Access Compliance Report

Public Rights-of-Way

Intersection ID: 6687	Main Street: NEVIN_RD	Cross Street: KAYRON_DR	Location: NE
ADA ID: 92F92AAD8487	Ramp Type: Directional1	Initial Pass/Fail: Fail	Overall Compliance: No
		Severity Score: 12.5

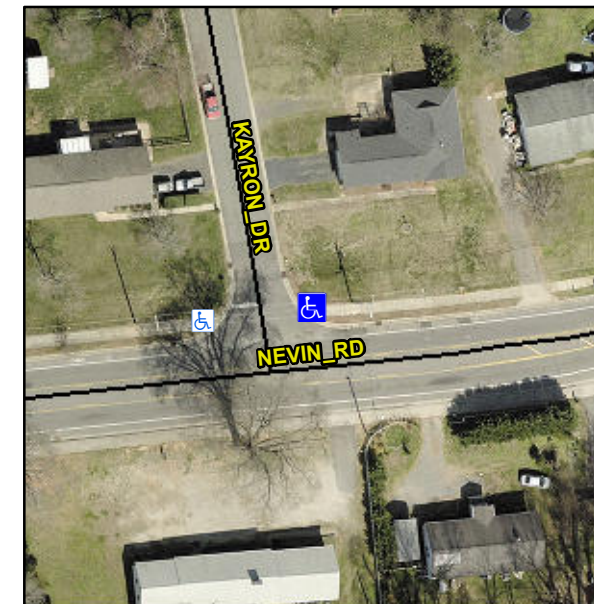
Compliance	Description	Data	Compliance	Description	Data
N/A	Ramp Length (in)	32.0	N/A	Grade Break?	N/A
Yes	Ramp Width (in)	72.0	N/A	Grade Break Slope (%)	0.0
Yes	Ramp Slope (%)	7.7	N/A	Grade Break XSlope (%)	0.0
No	Ramp XSlope (%)	6.2			
N/A	Flare Type LT	N/A	N/A	Flare Type RT	N/A
N/A	Flare Slope LT (%)	N/A	N/A	Flare Slope RT (%)	0.0
N/A	Flare Traversable LT?	N/A	N/A	Flare Traversable RT?	N/A
N/A	Landing Length (in)	0.0	N/A	DWS Provided?	N/A
N/A	Landing Width (in)	0.0	N/A	DWS Contrast?	N/A
N/A	Landing Slope (%)	0.0	N/A	DWS Length (in)	N/A
N/A	Landing X Slope (%)	0.0	N/A	DWS Full Width?	N/A
N/A	Landing Curb? (Y/N)	N/A	N/A	DWS Offset LT (in)	N/A
N/A	Shared Landing?	N/A	N/A	DWS Offset RT (in)	N/A
N/A	Gutter Ponding?	0.0	N/A	Gutter Slope (%)	N/A
N/A	Gutter Lip Ht (in)	3.0	N/A	Gutter X Slope (%)	N/A
N/A	Painted X Walk1?	No		Road Slope (%)	4.8
	X Walk 1 Direction	To W		Road X Slope (%)	6.3
	X Walk 1 Width (in)	N/A		Clear Space?	N/A

Remove & Replace Entire Ramp.

R304.5.3
